TITLE: **CHANGE OF ZONE NO. 04075B, an amendment to the Village Gardens Planned Unit Development,** requested by Village Gardens Development Company, LLC, on property generally located at South 63rd Street and Pine Lake Road.

LINCOLN/LANCASTER COUNTY PLANNING STAFF REPORT

PROJECT #: Annexation #11001
Change of Zone #04075B - Village Gardens Planned Unit Development (PUD)

PROPOSAL: To expand the existing PUD by annexing and changing the zoning from AG to R3 PUD for approximately 46.42 acres of land and amending the development plan to include provisions for assisted living facilities.

PHASE 2 - PLANNED UNIT DEVELOPMENT
SITE PLAN

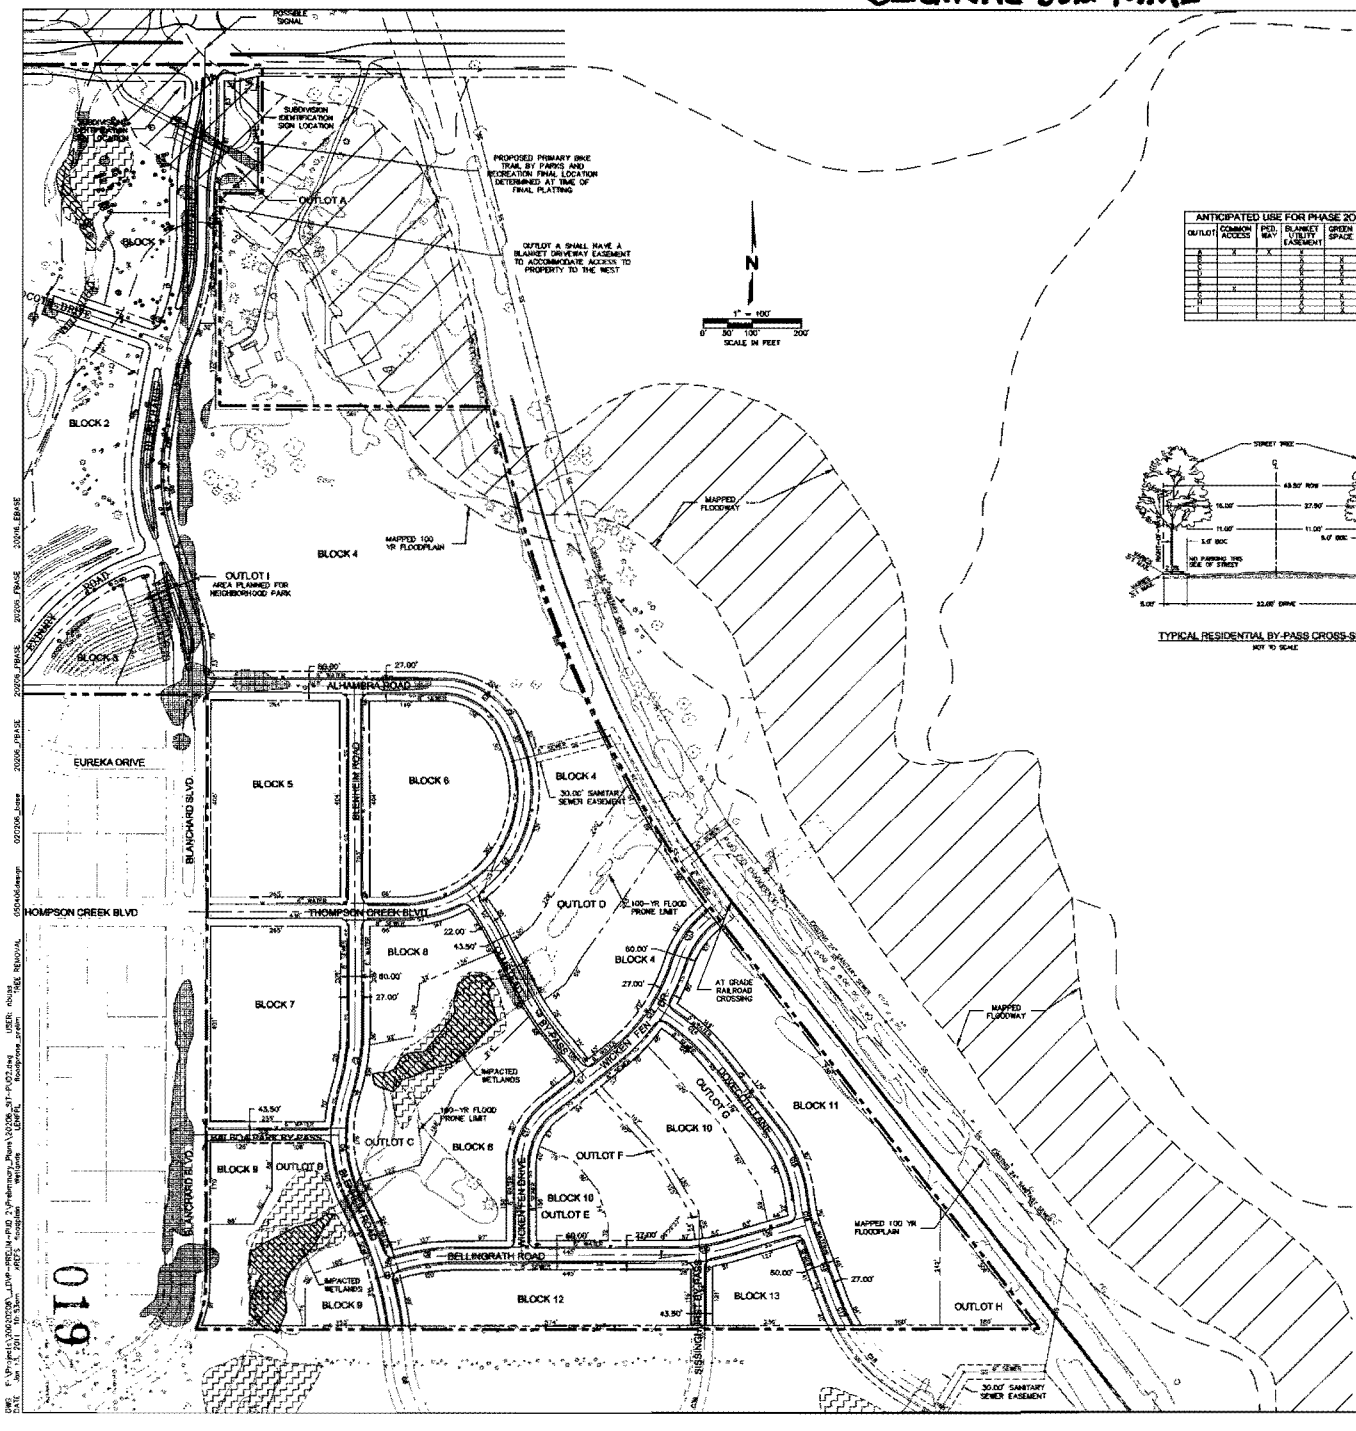
Sissinghurst does not appear to satisfy the same conditions and should be shown a typical-sized public street. The applicant has stated agreement with this comment. A no-parking restriction on one side of the street is proposed and appropriate.

7. Blenheim Road is essentially a north-south tending street, and LMC calls for such a street to typically be numbered. Given the lack of numbered streets in this development, the occasional numbered street will help in way-finding and allow people to more easily navigate through the area. Changing Blenheim to a numbered street would be appropriate. Also, 911 object to the name Olmstead due to similarity with Homestead Expressway and recommends another be selected.

2.9 Change the suffix of Sissingham from Way to some other acceptable suffix, and show it as a typical-sized public street.

2.10 Select a street name other than Olmstead to the satisfaction of 911.

2.12 Add a note that states “Parking will be restricted to one side of the street on Olmstead and Balboa Park Ways.

2.13 ~~Revise the Development Plan as appropriate to require that the minimum setback for dwellings adjacent to Olmstead and Balboa Park Way is 20'.~~ Add a note that a setback easement for the sight triangle shall be granted on the final plat for the lots adjacent to the reduced right-of-way abutting Olmstead and Balboa Park Way, to the satisfaction of the Planning Department. **(**Per Planning Commission, as requested by the Applicant, 02/09/11**)**

TYPICAL RESIDENTIAL 'WAY' CROSS-SECTION

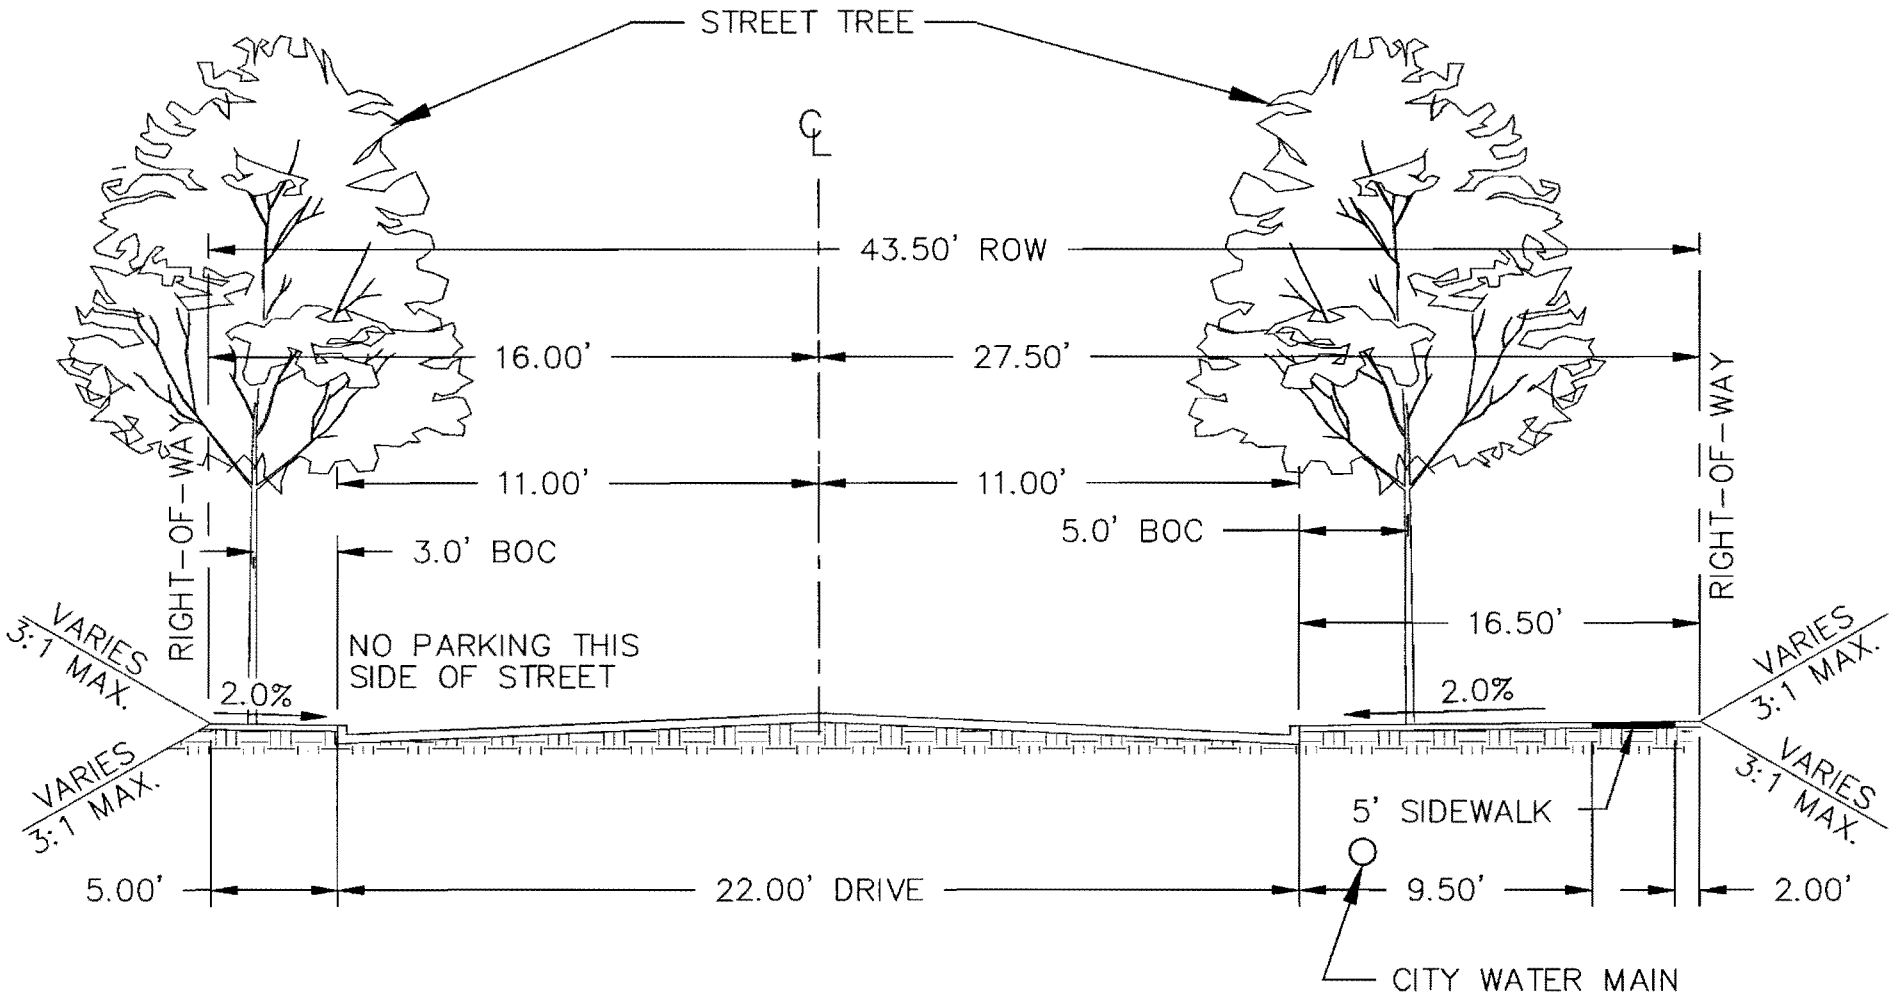
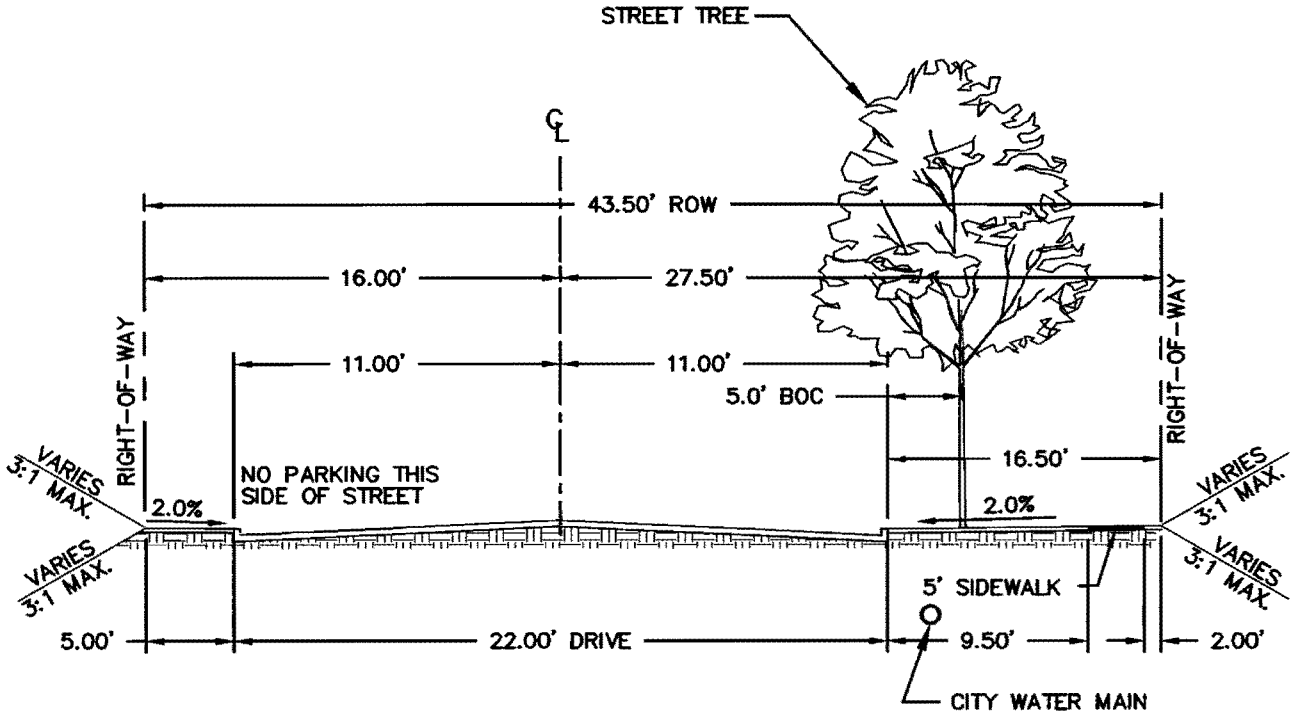
It is noted that 911 Emergency Communications objects to the use of the term 'by-pass' for the reduce-width streets. This has already been discussed with the applicant, and a revised plan using the suffix 'Way' instead is attached.

A. LMC 26.23.190 - Adjust the street right-of-width from 60' to 43.5'. This request would allow for a 22'-wide paved street surface, which was initially is identified by the term 'by-pass' on the site plan, but is now shown as 'Way' on the revised plan now also attached. There are three such streets shown on the plan: Balboa Park, Olmstead, and Sissinghurst. The blocks where Olmstead and Balboa Park are shown would otherwise exceed the maximum block length, and both serve to reduce block length and enhance connectivity. Without them, a waiver to block length would be required to not construct a street, and a pedestrian connection would also need to be shown since the block exceeded 1,000'. However,

B. LMC 26.27.020 and 090 - To allow a sidewalk and street trees on only one side of the reduced-width street. Staff has been considering alternatives to the standard 1,320' block length requirement LMC 26.23.130 which states: I - Block lengths shall not exceed 1,320' between cross-streets except where a major street, other man-made barrier, lake, or other natural barrier forms one boundary of a block; II - At the sole determination of the city, the 1,320' maximum block length may be increased if substantially different zoning or land use forms one boundary of the block.

In their comments, Public Works objects to this reduced-width standard, noting a potential conflict with State street design standards, and the lack of a demonstrated hardship on the part of the applicant.

2.8 Change the street suffix from ‘By-Pass’ to ‘Way’ for Olmstead and Balboa Park.

2.14 Revise the cross-section on the site plan to show a sidewalk and street trees on only one side of the reduced-width street.
